Common Comments Made on Sanitary Sewer Plans

**Presentation to
Building Industry Association of Central Ohio**

By: Delaware County
Sanitary Engineer's Office
February 4, 2015

Common Comment #2: (Example)

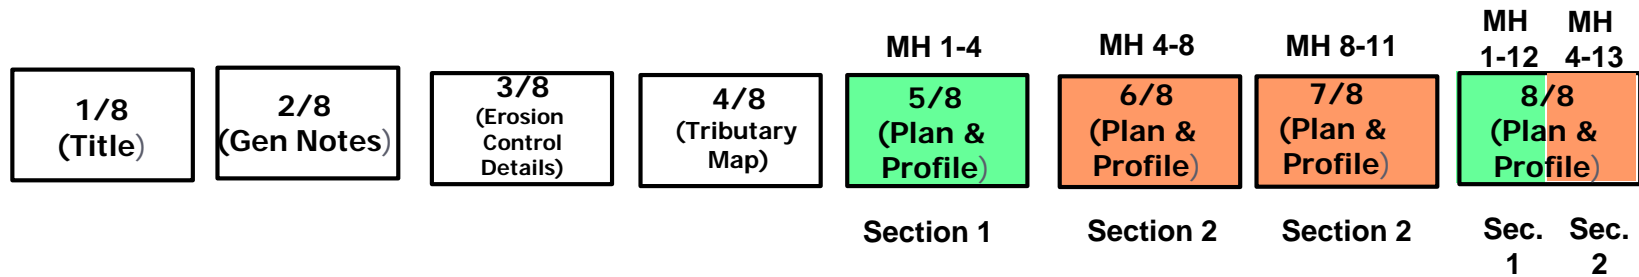
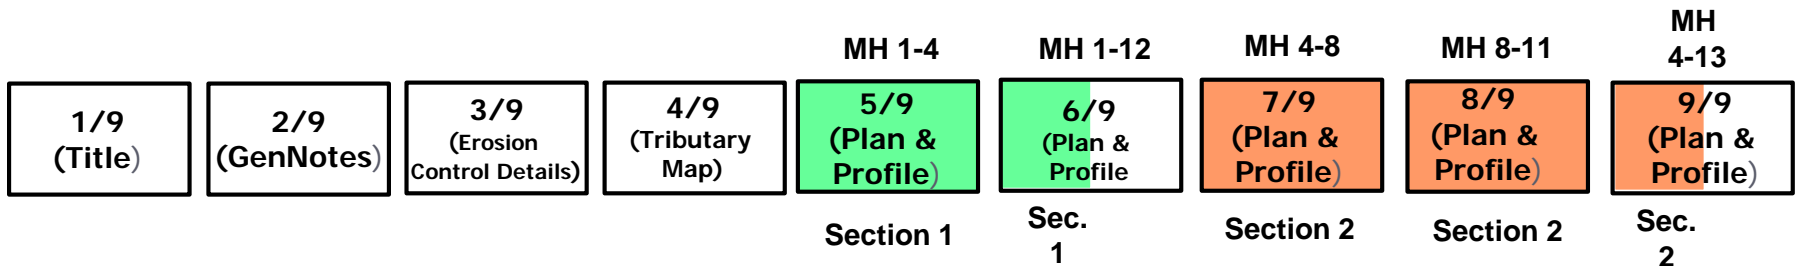
If a plan set includes multiple sections, please place all Sections in a sequential order. (i.e. show all of Section 1 Sheets before any Section 2 sheets are introduced)

Common Comment #3: Sanitary Alignments Along Straight Roads

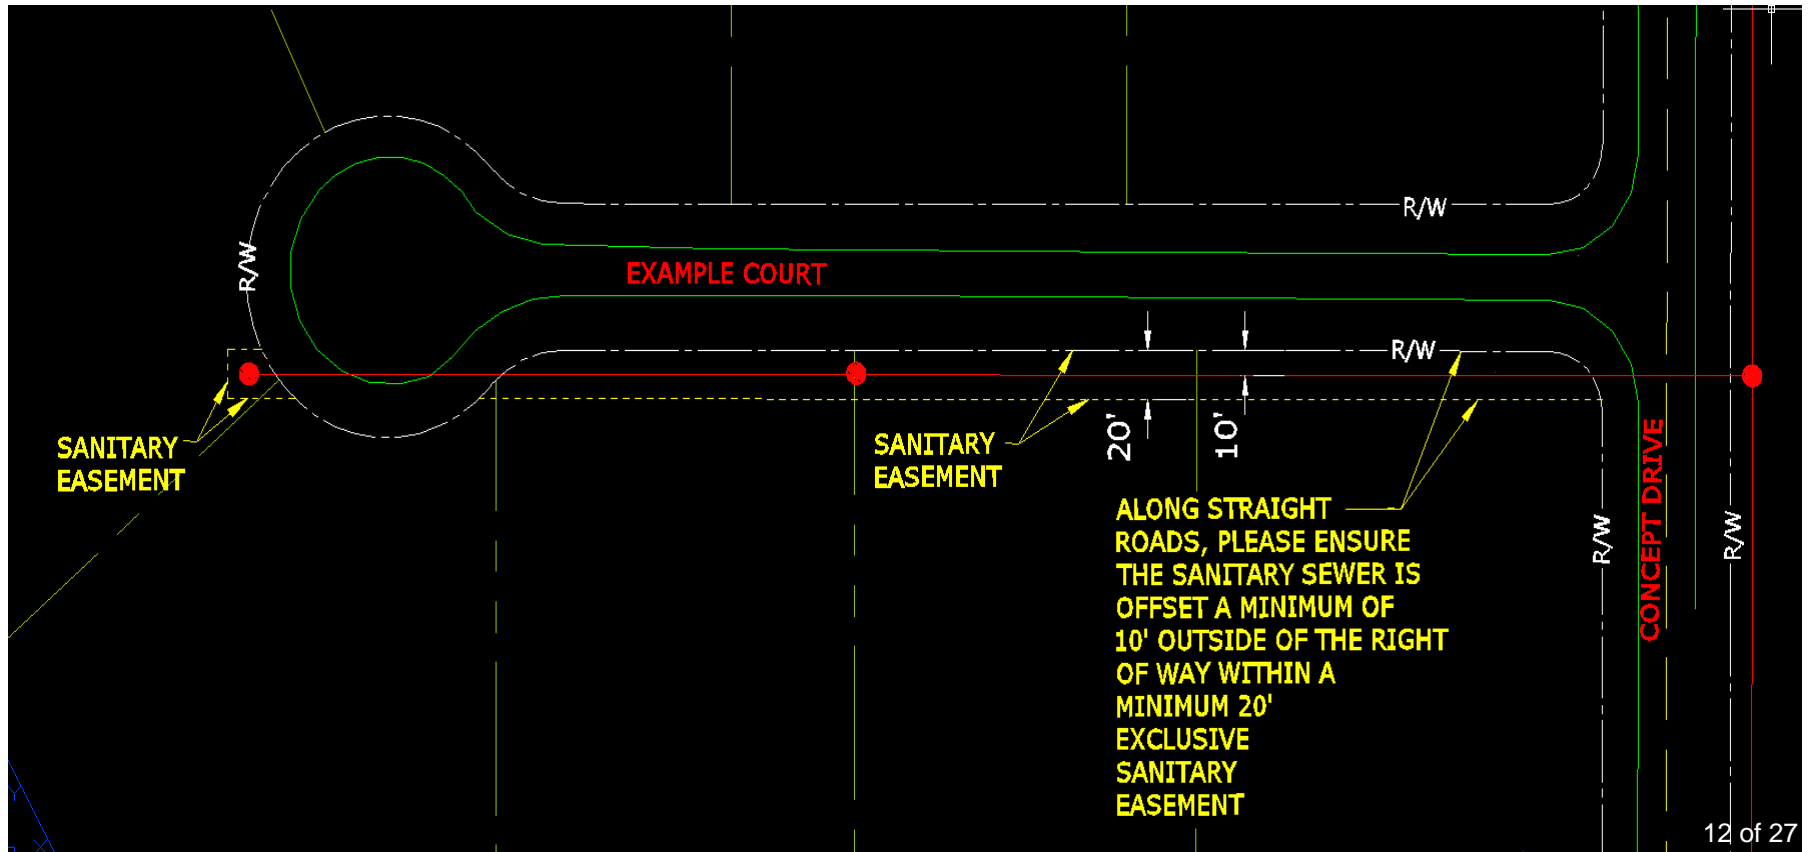
Please ensure sanitary sewer is a minimum of 10' off of the R/W within a minimum 20' exclusive sanitary easement

Common Comment #4: Sanitary Alignments Along Curved Roads

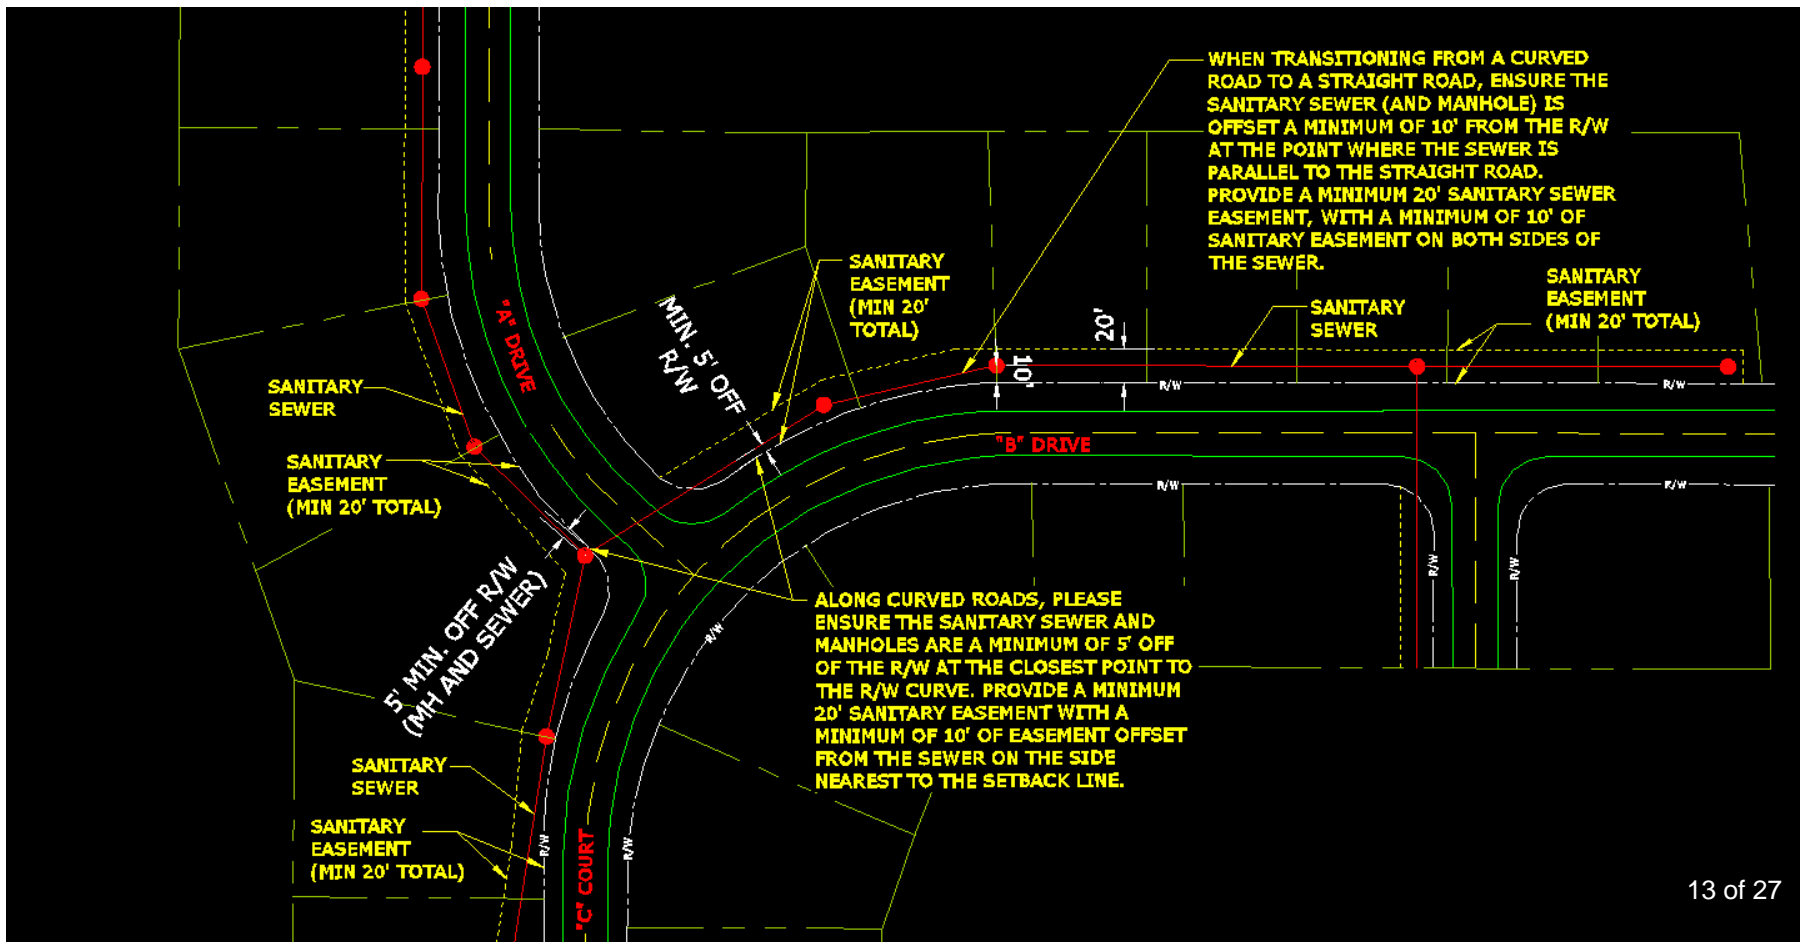
Please ensure all sections of the sanitary sewer and manholes are a minimum of 5' off of the R/W at the closest point to the R/W. Provide a 20' minimum exclusive sanitary easement.

Common Comment #5: No Acute Angles

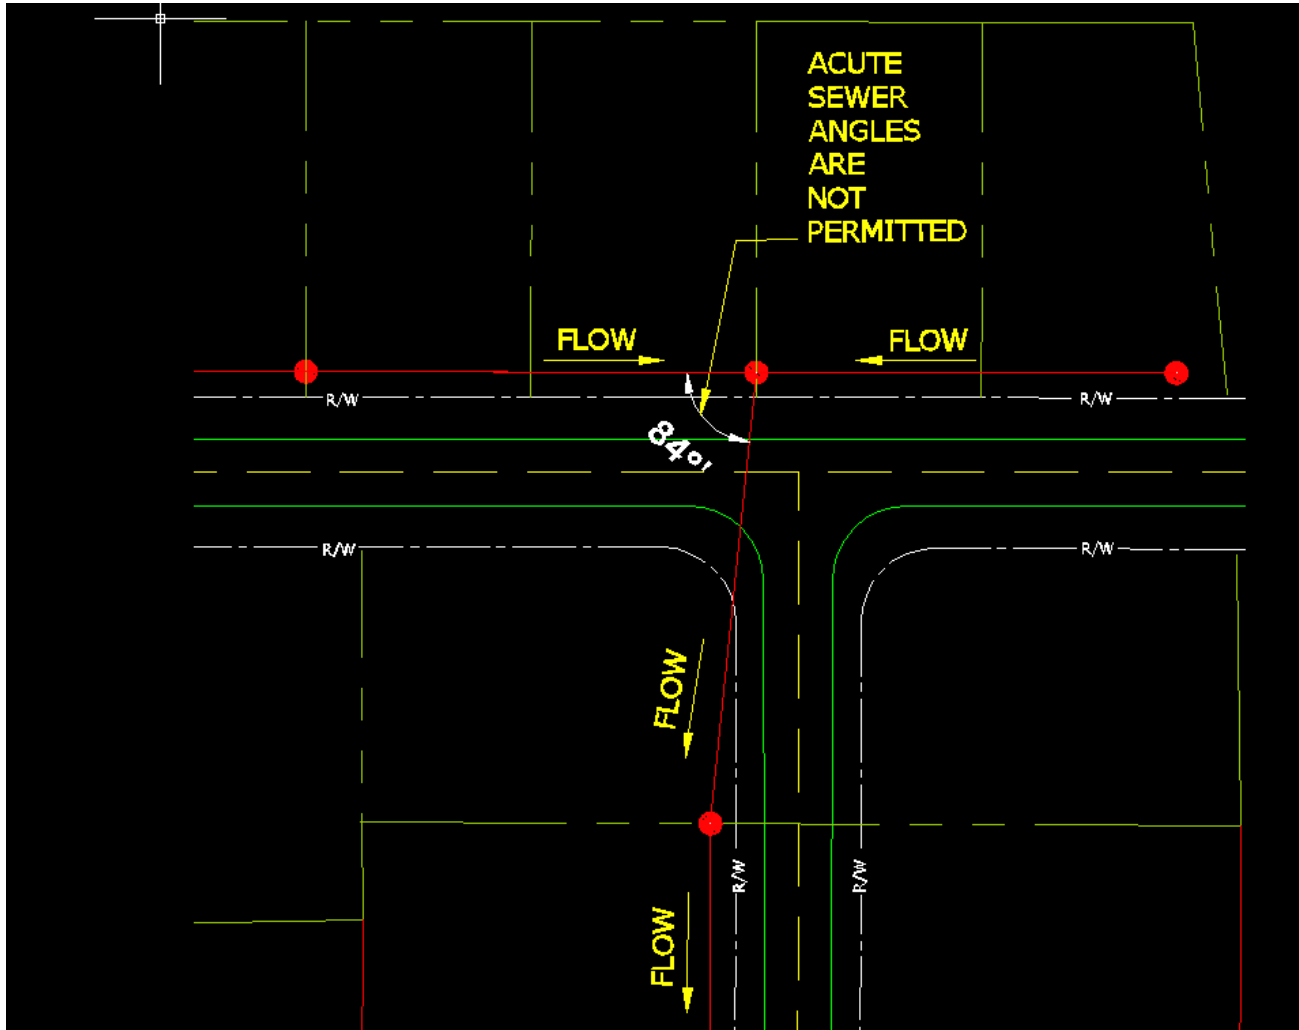
Please ensure there are no acute sewer angles on the plans.

Common Comment 6 Example

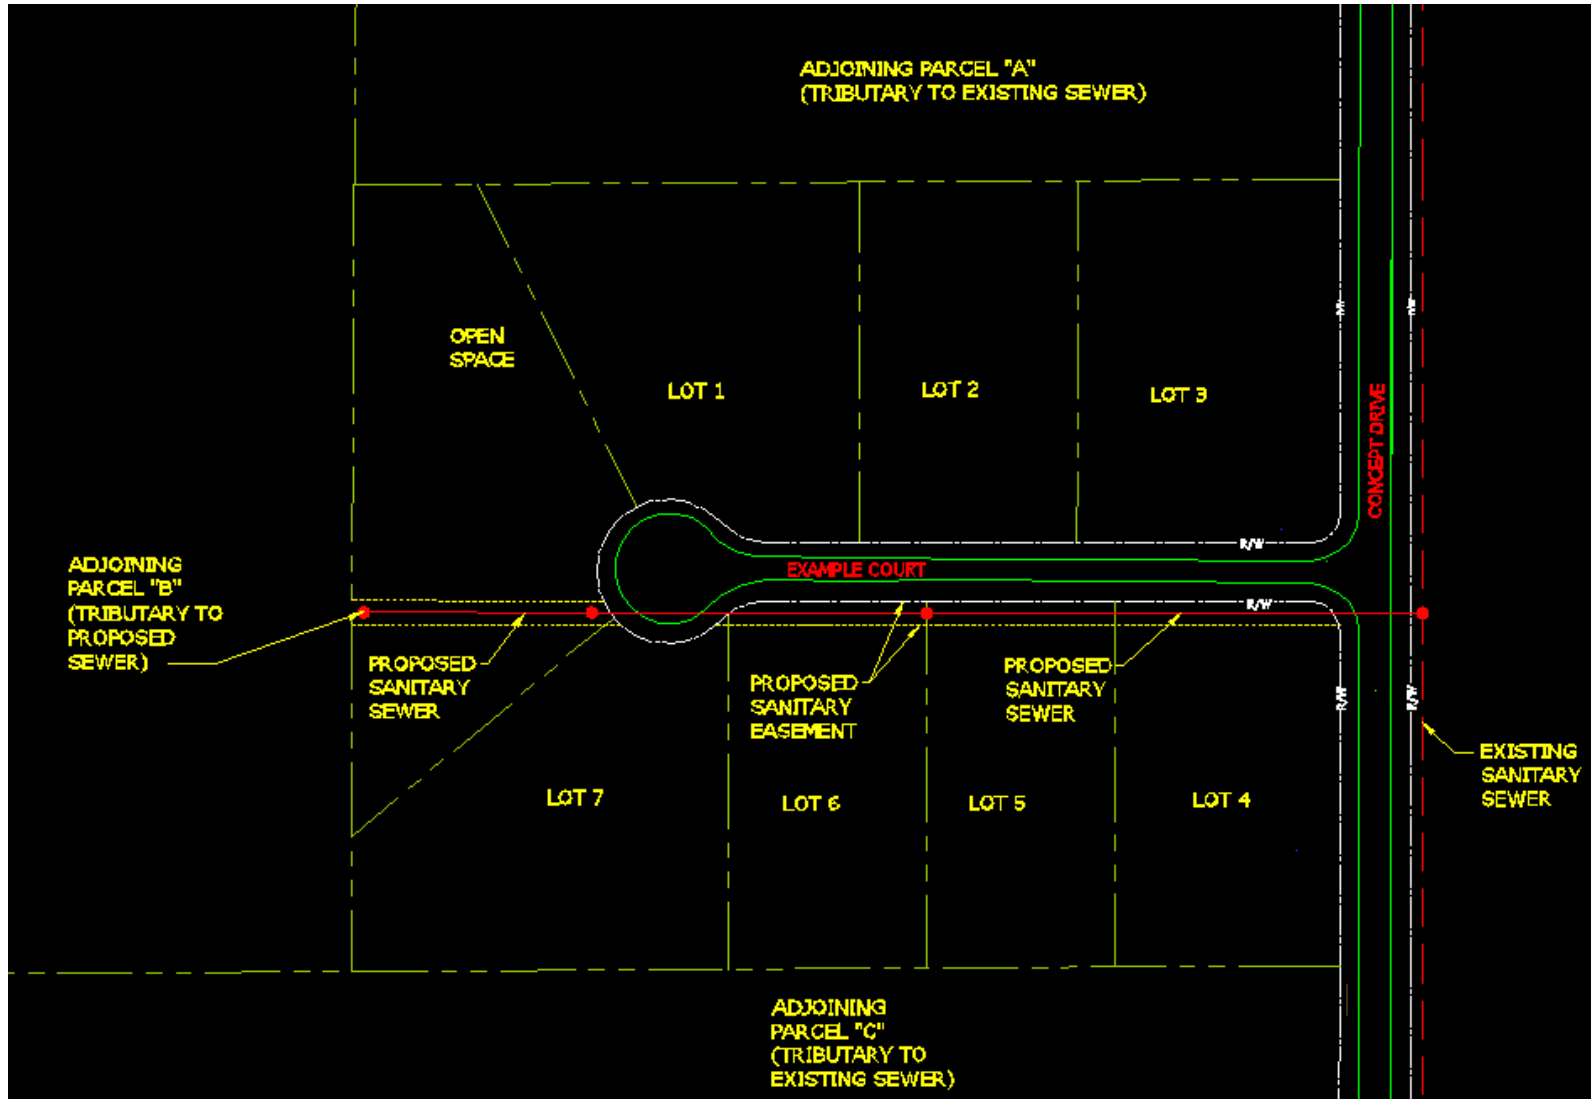
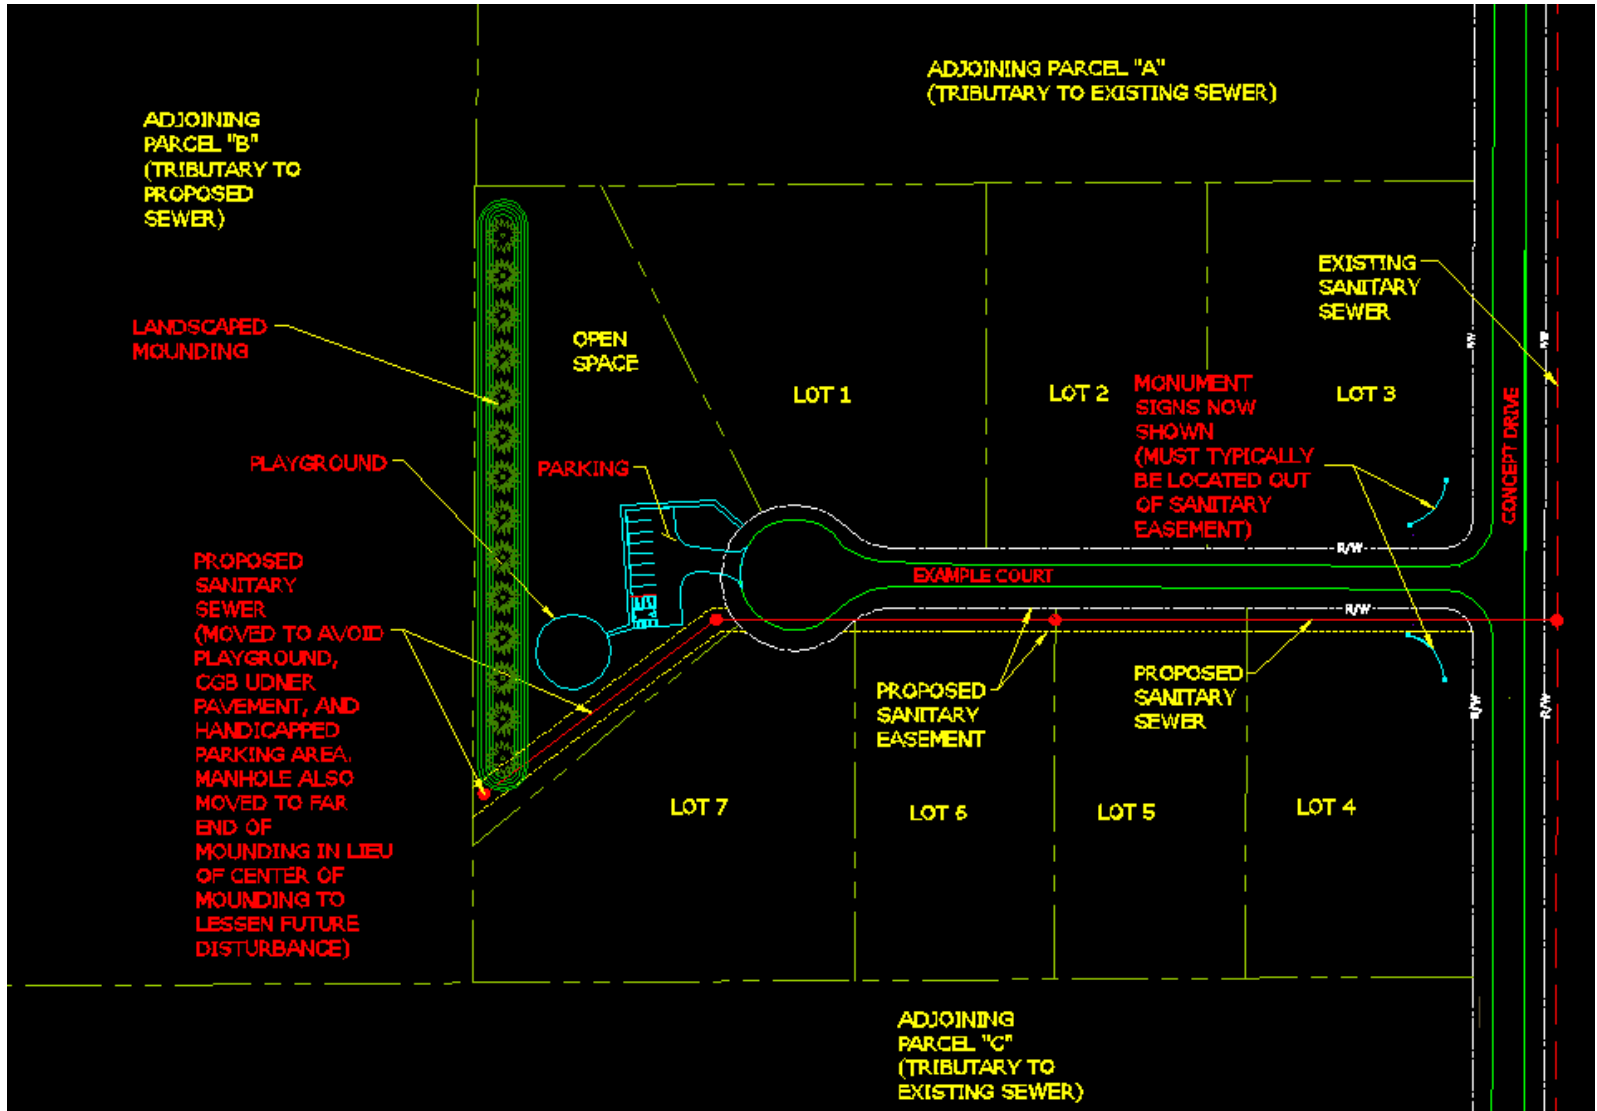
Consult the zoning documents and show various features which may affect the sanitary sewer plans

Common Comment #7: Consult the Environmental Permits and Reports

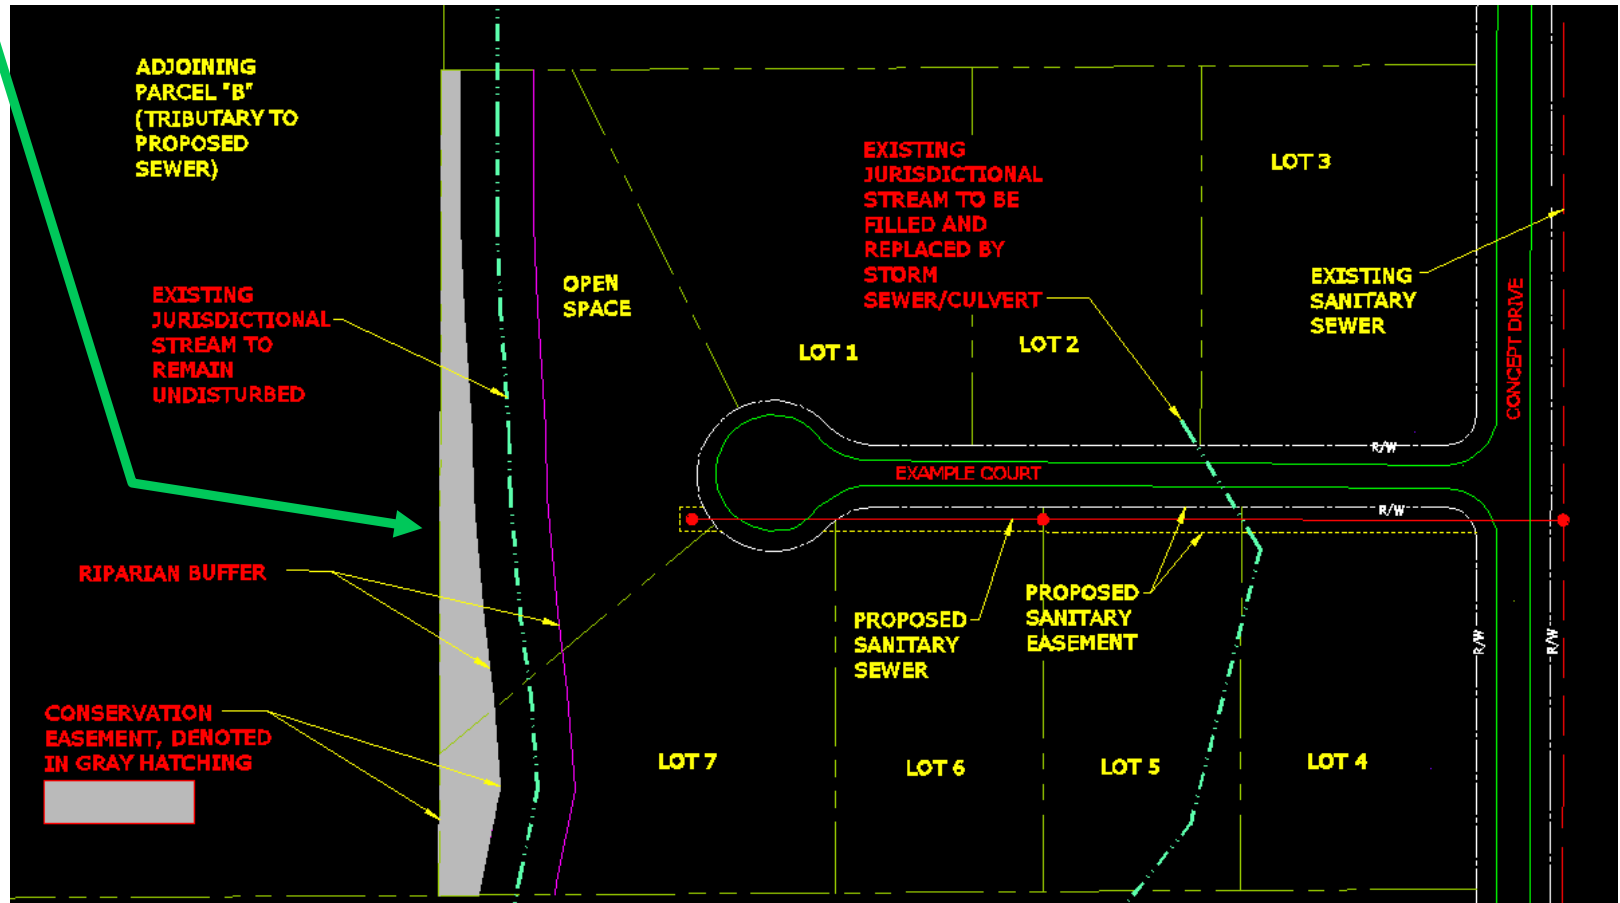
Items to be shown on the sanitary plans (existing and proposed) may include, but are not limited to:
